**CONCEPT PLAN REVIEW: LULLWATER PARK (Project #CP-22-2)  
SUMMARY REPORT**

TOWN OF CHAPEL HILL PLANNING DEPARTMENT  
Colleen Willger, Director  
Judy Johnson, Assistant Director  
Corey Liles, Planning Manager

<p><b>PROPERTY ADDRESS</b></p> <p>860 Weaver Dairy Rd.</p>	<p><b>MEETING DATE</b></p> <p>September 28, 2022</p>	<p><b>APPLICANT</b></p> <p>CJT, PA on behalf of NGI Acquisitions, LLC</p>
<p><b>STAFF RECOMMENDATION</b></p> <p>That the Council adopt the attached resolution transmitting comments to the applicant regarding the proposed development.</p>		
<p><b>PROCESS</b></p> <p>Council hears from the applicant, receives comments from the Community Design Commission, Stormwater Management Utility Advisory Board, Housing Advisory Board, hears public comments, and offers suggestions to the applicant.</p> <p>Because this review is a Concept Plan submittal, statements by individual Council members this evening do not represent an official position or commitment on the part of a Council member with respect to the position he or she may take when and if the Council considers a formal application.</p>	<p><b>DECISION POINTS</b></p> <p>A Conditional Zoning review is typically required f

### **Stormwater Management Master Plan**

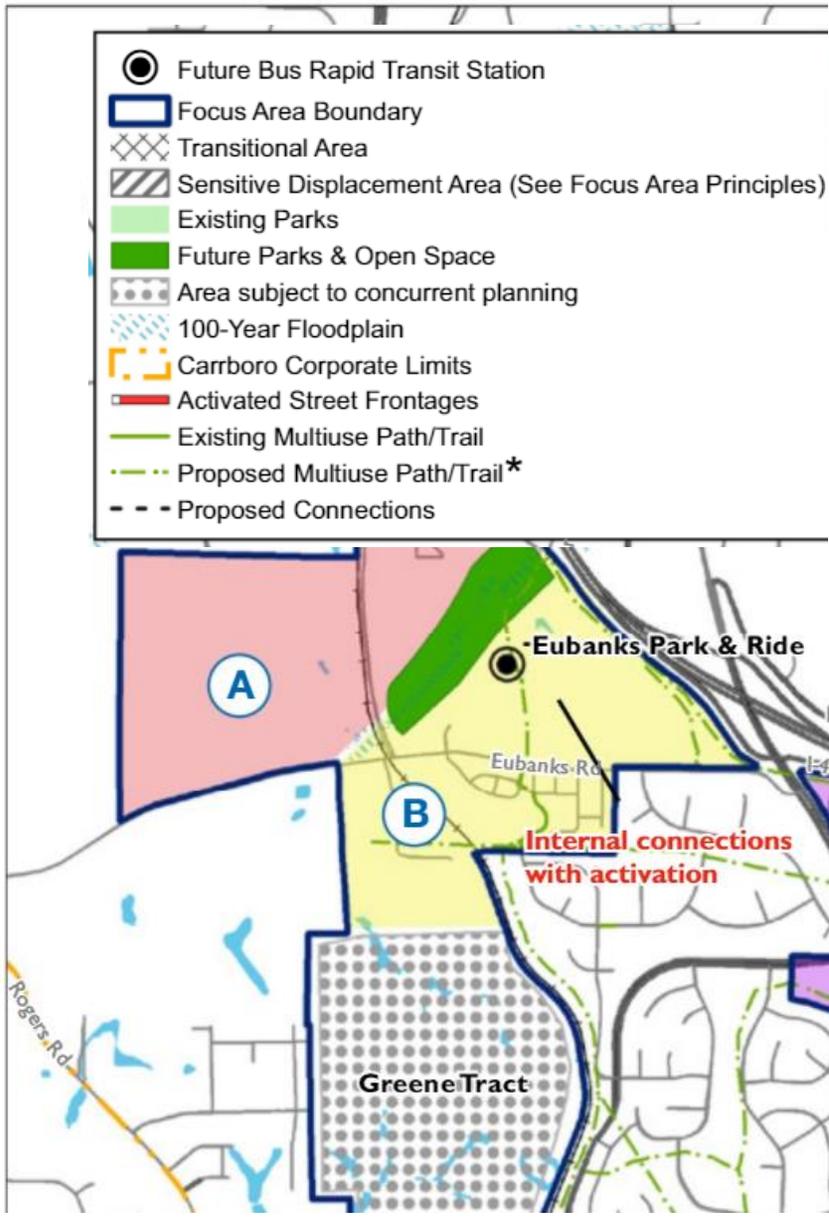
- The site is mostly located in the Old Field Creek Subwatershed (NH1), with an eastern portion of the site located in the Cedar Fork Subwatershed (BL8). The applicant should **coordinate with Chapel Hill's Stormwater Management Division** to understand relevant stormwater considerations.
